Re: **Seventh (Technical) Submission Review –** **Porteos** (Infrastructure CSP)  
Application Number: **DA-1903-13**  
Case Number: **2019-6032-00**

Thank you for taking the time to review our seventh submission of Porteos Phase 5 Powhaton ISP. We received your comments on May 8, 2020. Responses to comments have been provided below. The following items have been included in the resubmittal:

## Seventh Submission Review

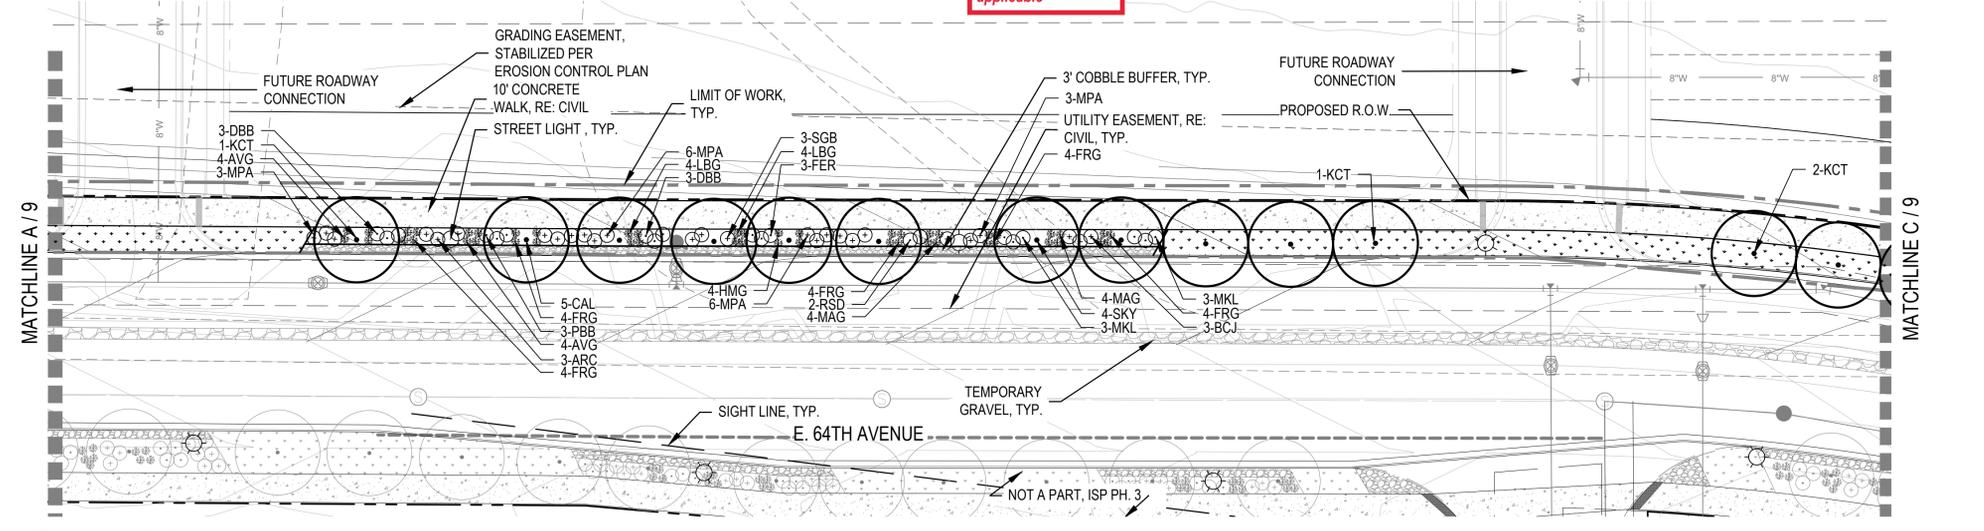
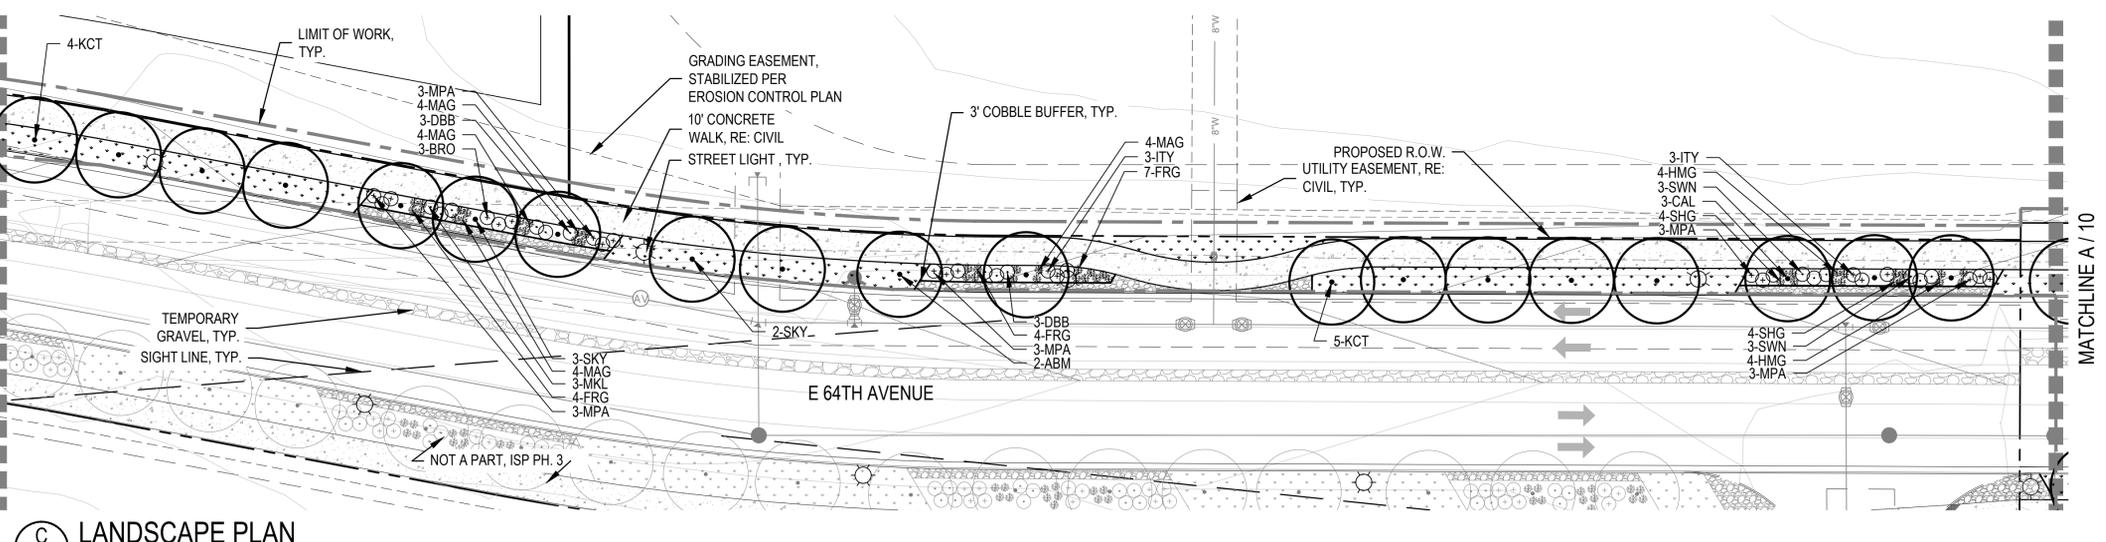
add a note to all sheets where applicable... Refer to Porteos Contextual Site Plan No 3. CN# 2018-4018-00

Response: Note has been adjusted where applicable

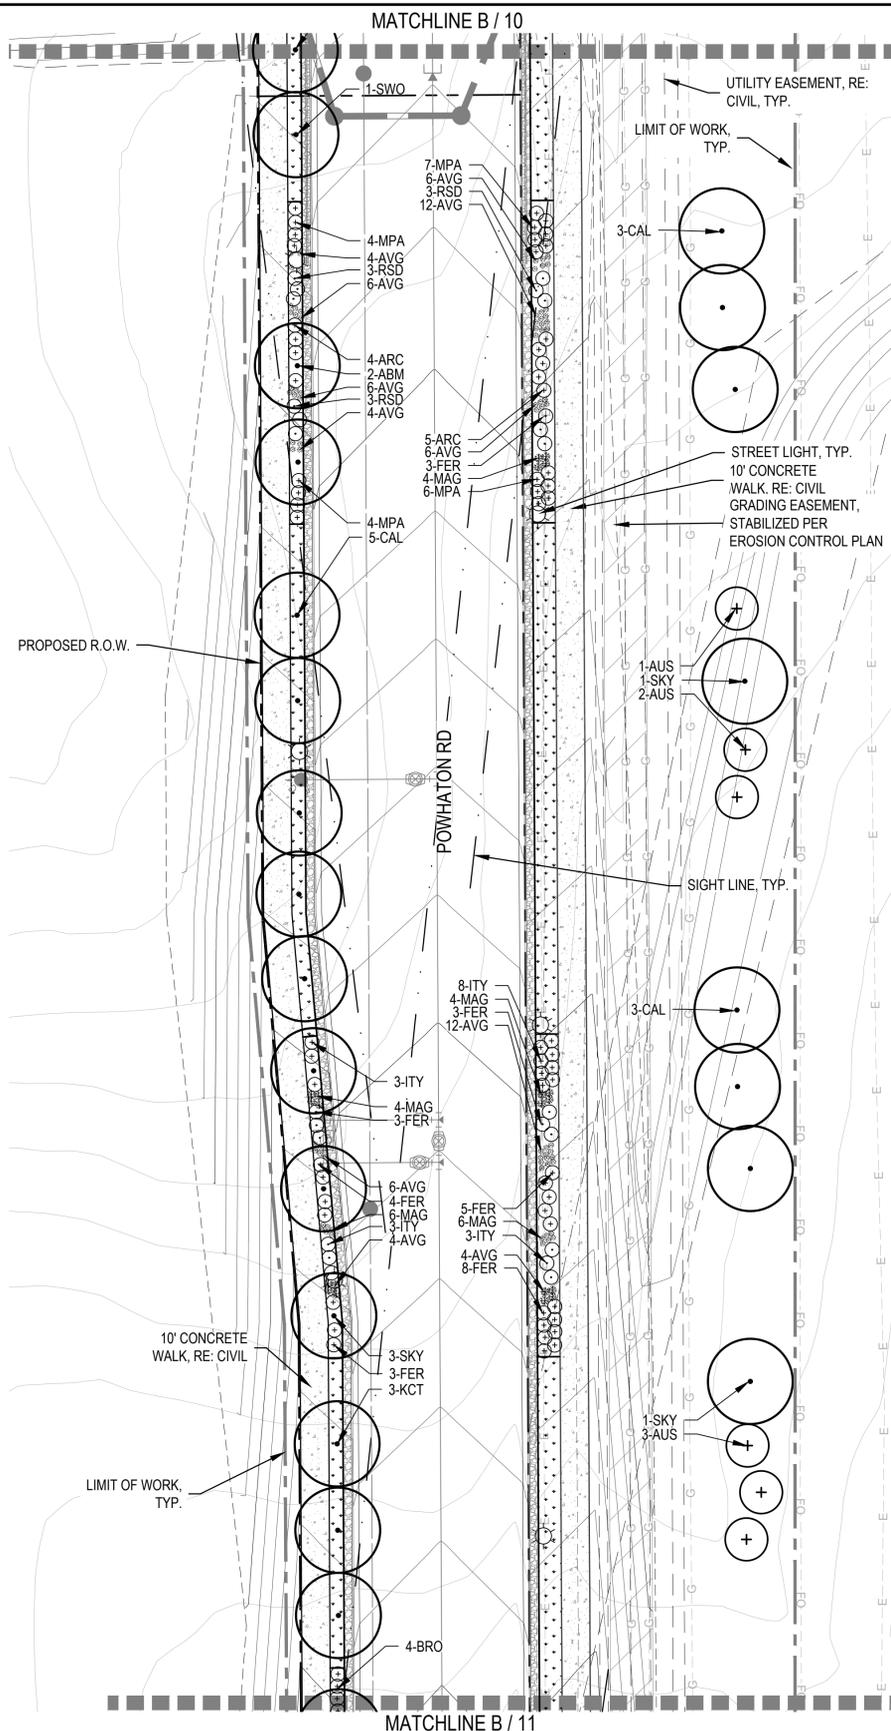
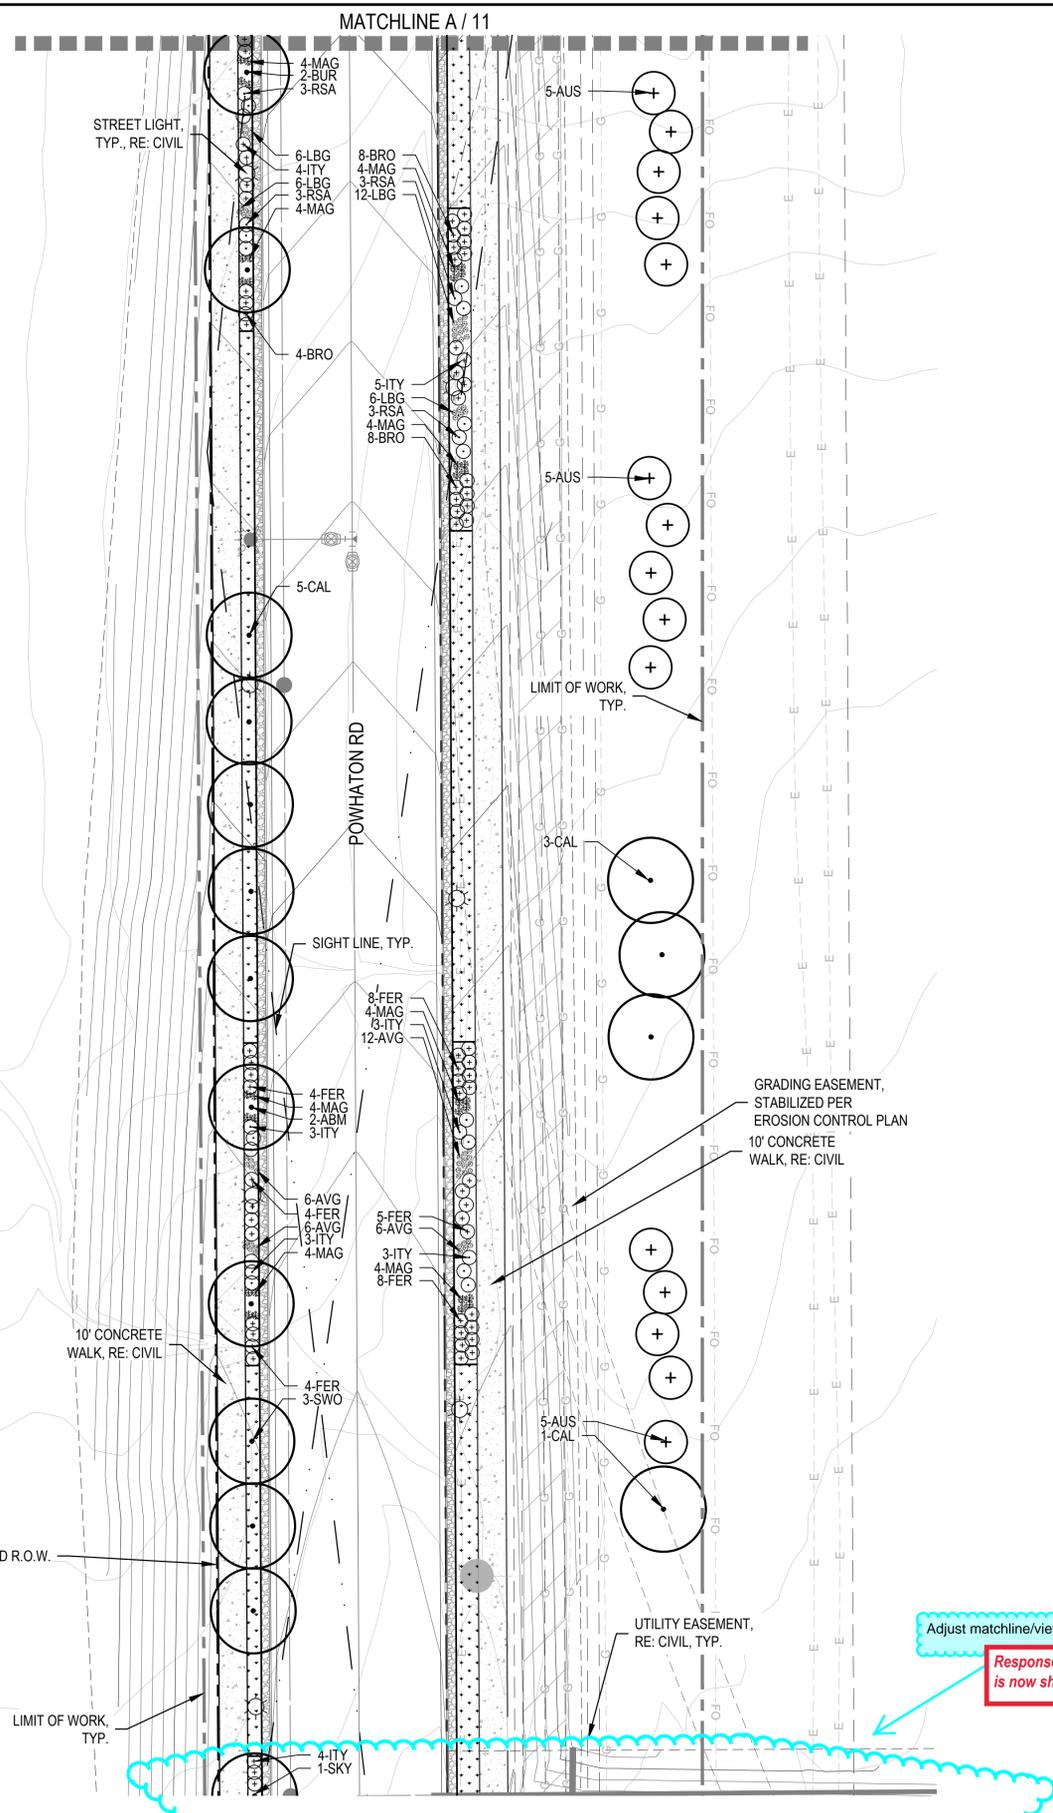
Adjust matchline/viewport  
Response: Matchline is now shown

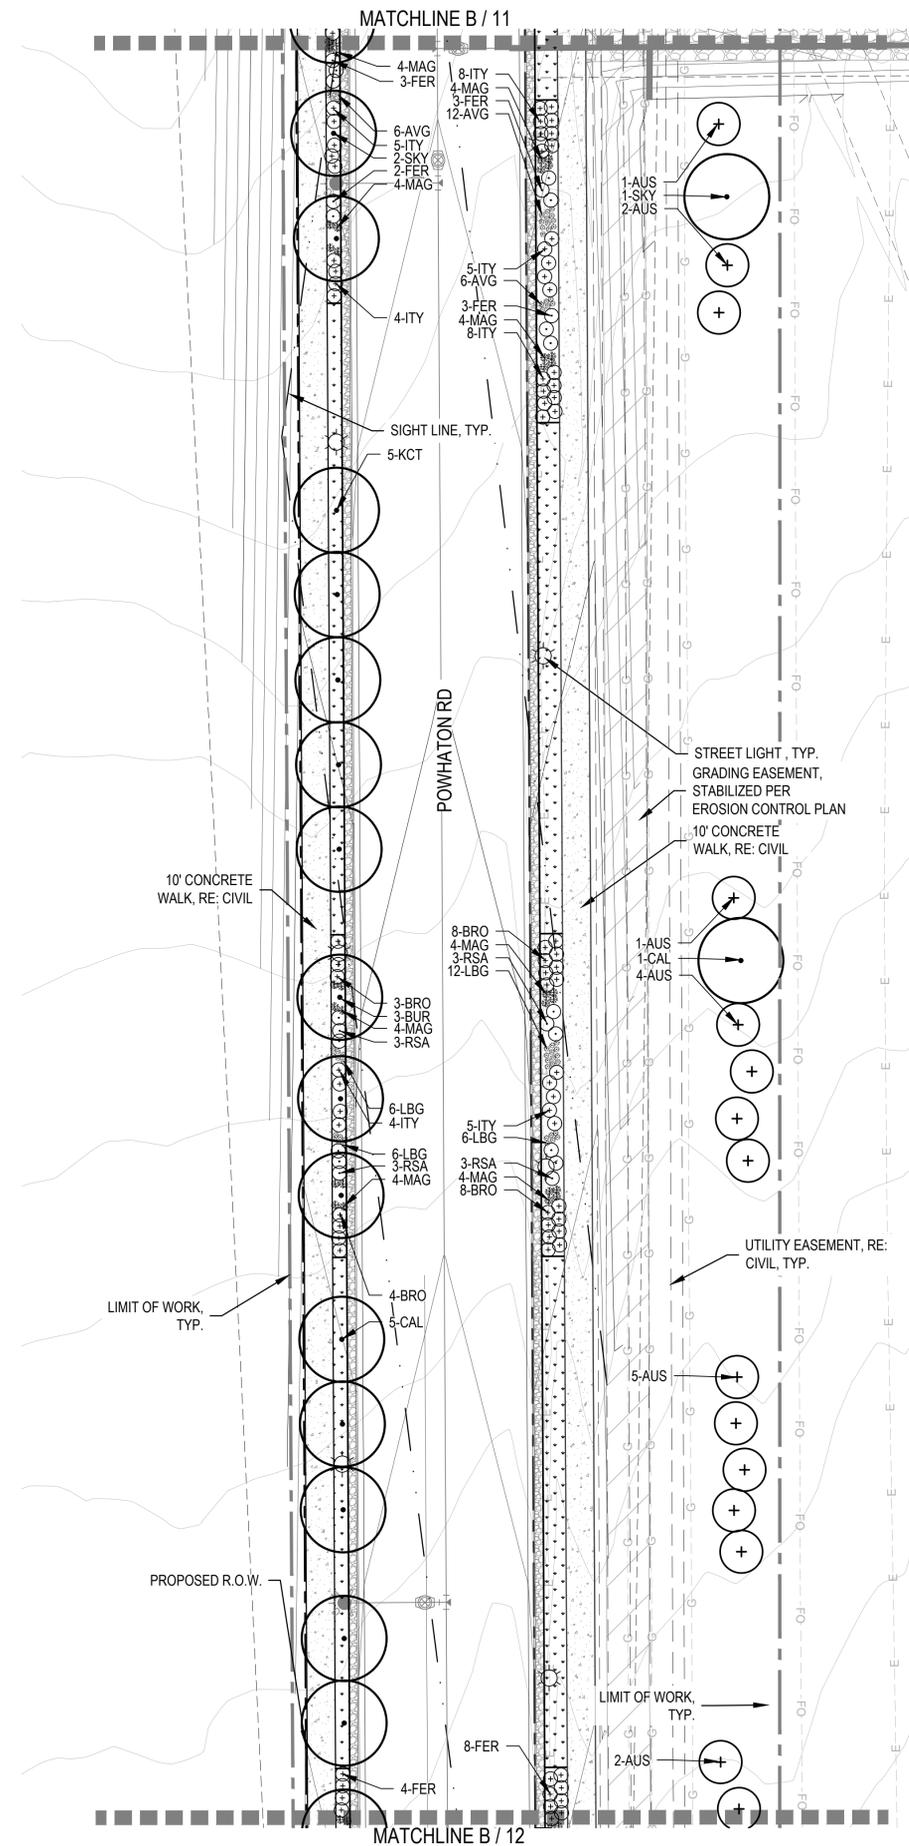
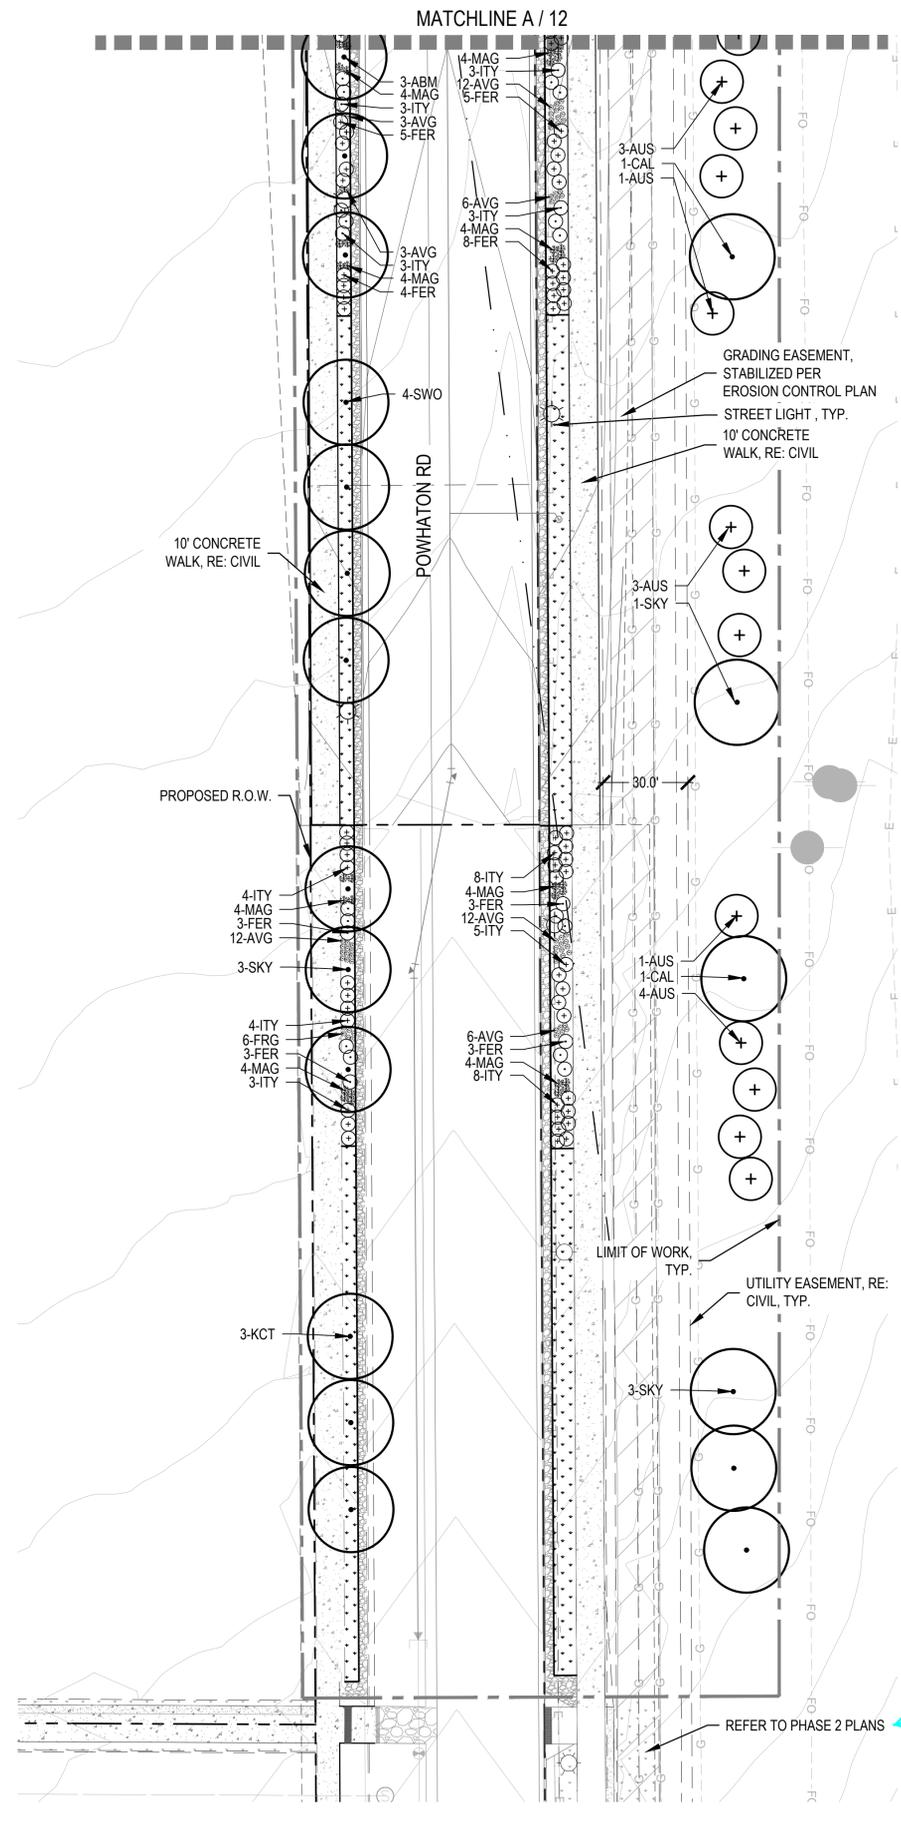
Add to this... Refer to Infrastructure Site Plan No. 2 at Porteos CN: 2016-6028-01

Response: Note has been adjusted.
